Service note for VAG accessory unit drives with 1.9 TDI engines without an over-running alternator pulley

Engine: 1.9 TDI

Item no.: 533 0081 30 (TU)*

Figure 1: Tensioning unit 533 0081 30 - used in 1.9 TDI engines

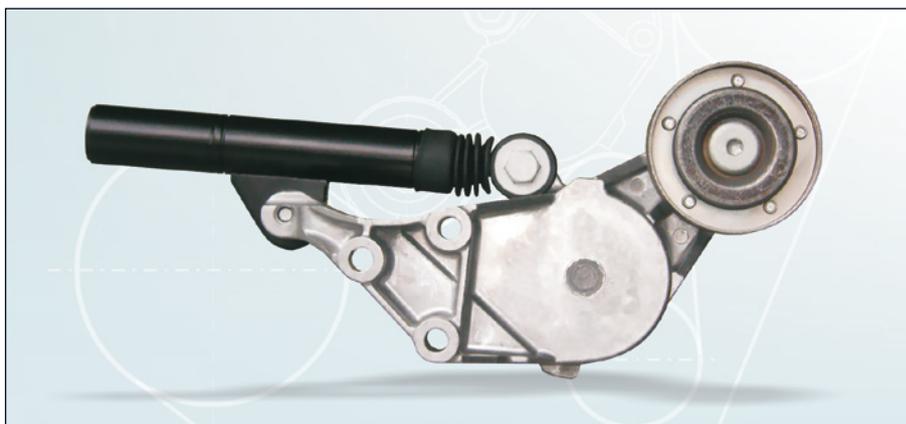
In the worst case, excessive dynamic movement of the poly V-belt can lead to noise build-up, or even damage to the poly V-belt tensioner.

This leads to a failure of the complete assembly drive, which causes the vehicle to break down.

In assembly drives with the tensioning unit 533 0081 30 (Figure 1), the rigid belt pulley on the alternator must be replaced with an INA over-running alternator pulley (Figure 2). If an over-running alternator pulley has already been fitted, this must be checked to ensure it is operating correctly.
